14. DESCRIPTION OF AMENDMENT/MODIFICATION (Organized by UCF section headings, including solicitation/contract subject matter where feasible.) AMENDMENT 0007 N40080-16-R-1010 Demolish Buildings 2112, 2130, 2131, MCB Quantico, VA 1. Provide Responses to RFTs. 2. All other terms remain unchanged See Continuation Page.				
Except as provided herein, all terms and conditions of the document referenced in Item 9A or 10A, as heretofore changed, remains unchanged and in full force and effect.				
15A. NAME AND TITLE OF SIGNER (Type or print)		16A. NAME AND TITLE OF CONTRACTING OFFICER (Type or print)		
		TEL:	EMAIL:	
15B. CONTRACTOR/OFFEROR _____ (Signature of person authorized to sign)	15C. DATE SIGNED	16B. UNITED STATES OF AMERICA BY _____ (Signature of Contracting Officer)		16C. DATE SIGNED 12-Sep-2016

N40080-16-R-1010 Larson's Gym Demo**AMENDMENT 0007****Responses to RFI:**

Demolition of Larson's Gym (Bldg 2112), Bldgs 2130/2131 & Ancillary Structures
Marine Corps Base Quantico
Quantico, Virginia

Figure C

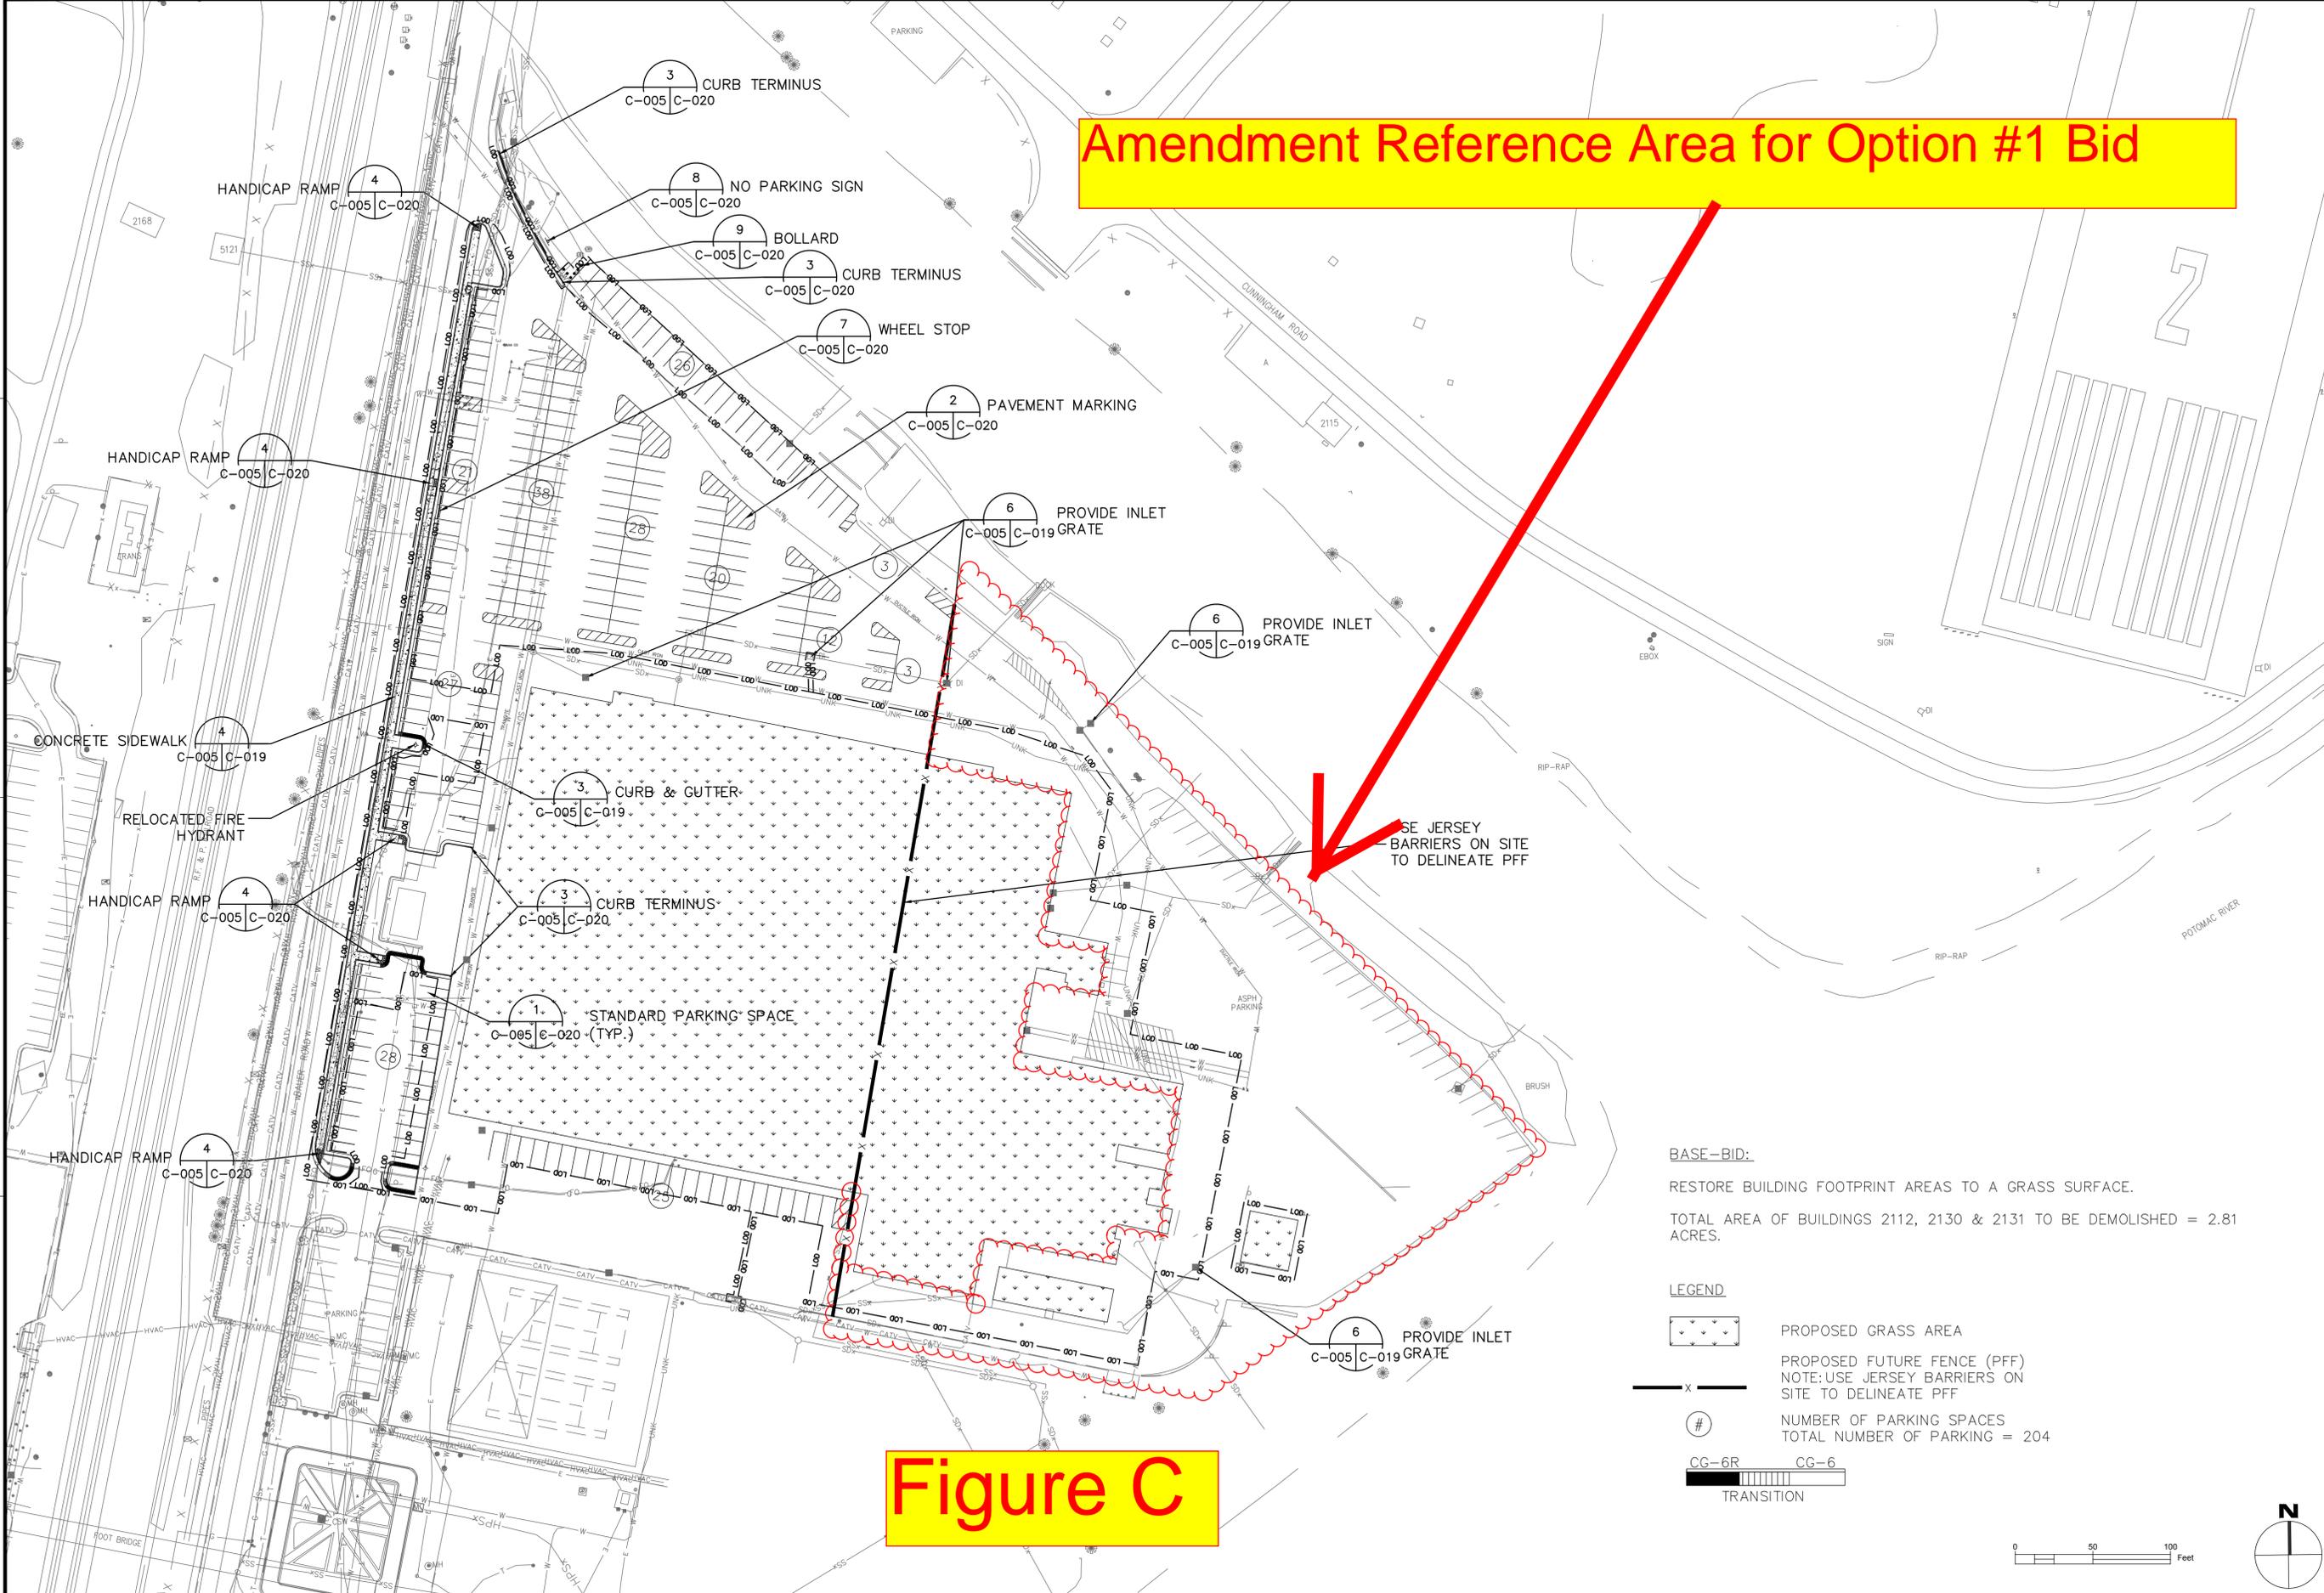
For the Bid Schedule & Design Package: Item 0002 (OPTION #1), work associated with the parking lot shall be accomplished after the buildings are demolished and all the heavy equipment and dump trucks used to accomplish the action are no longer used. See Figures C.

BASE-BID:
 RESTORE BUILDING FOOTPRINT AREAS TO A GRASS SURFACE.
 TOTAL AREA OF BUILDINGS 2112, 2130 & 2131 TO BE DEMOLISHED = 2.81 ACRES.

Q20_Drawing

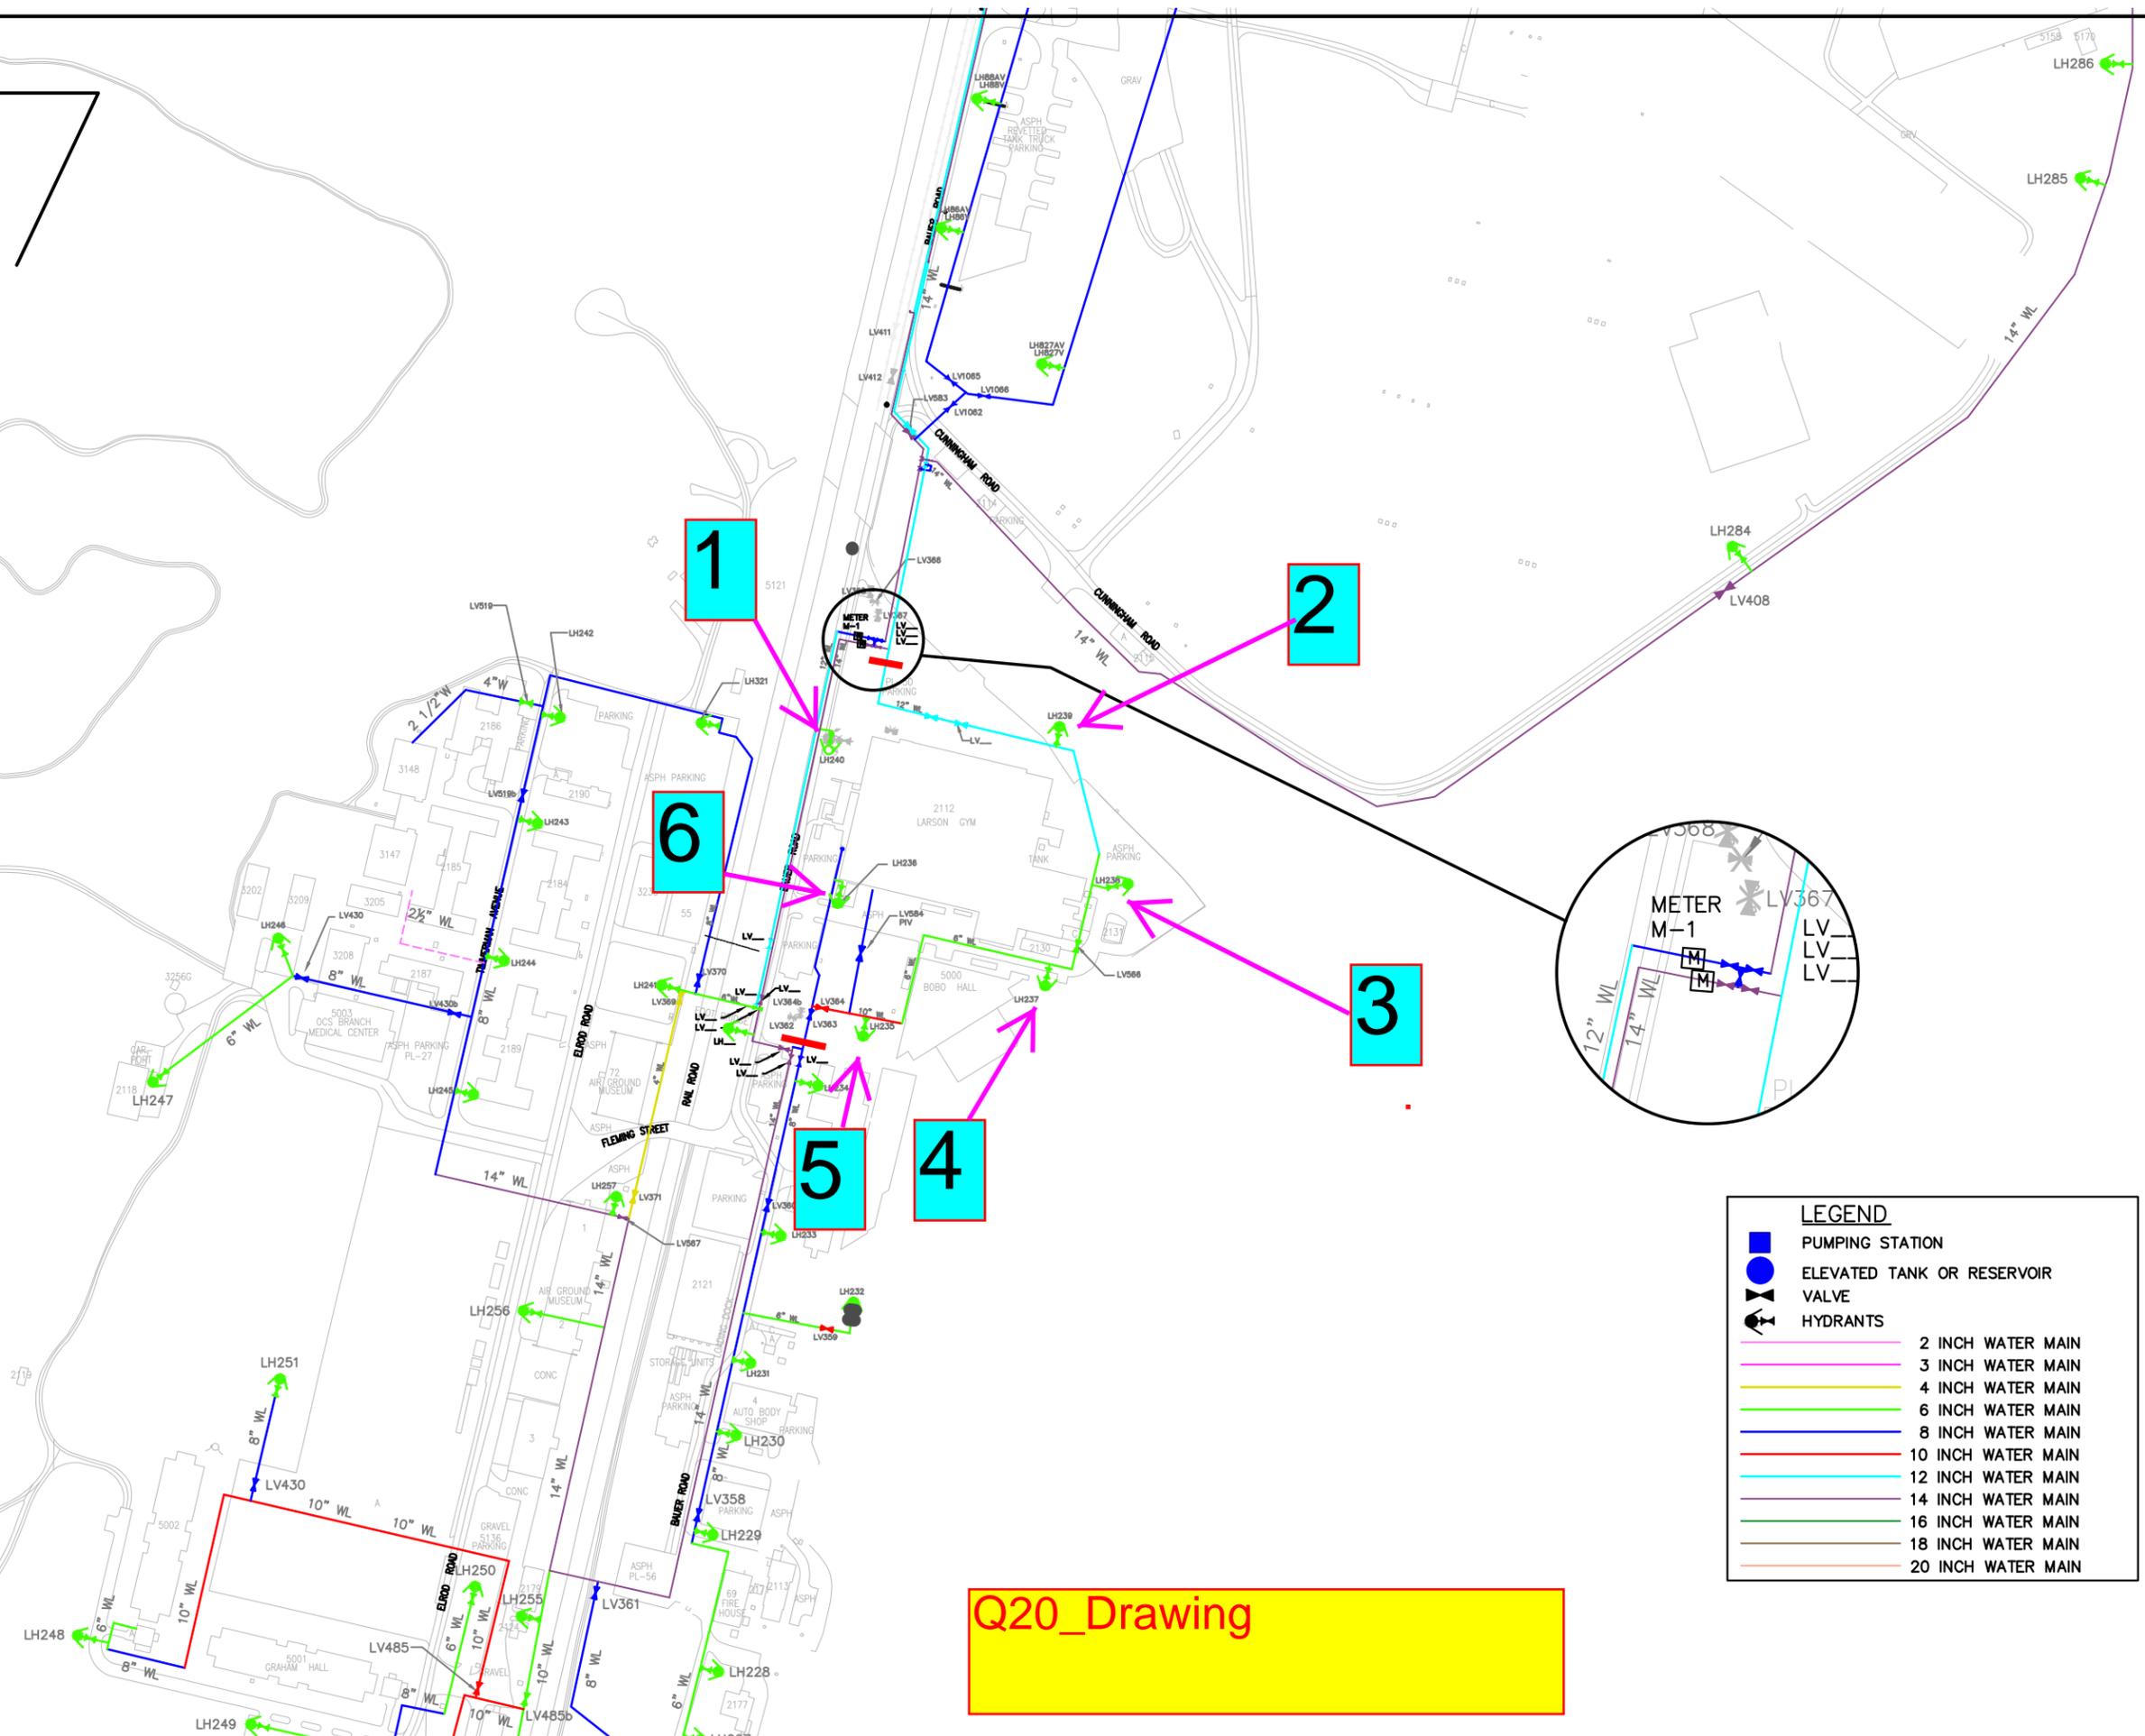
Question (19): Can you show the locations of any hydrants we can use during demolition activities for dust control.

RESPONSE: On the attached drawing (Q20_Drawing), hydrant #'s 1, 2, 4, and 6 are active and can be used for dust control providing the contractor follows the installation's procedures for connecting to the water distribution system (i.e backflow preventers, etc). Hydrant #3 has been removed and no longer exists. The other remaining hydrant #5 is not functioning.
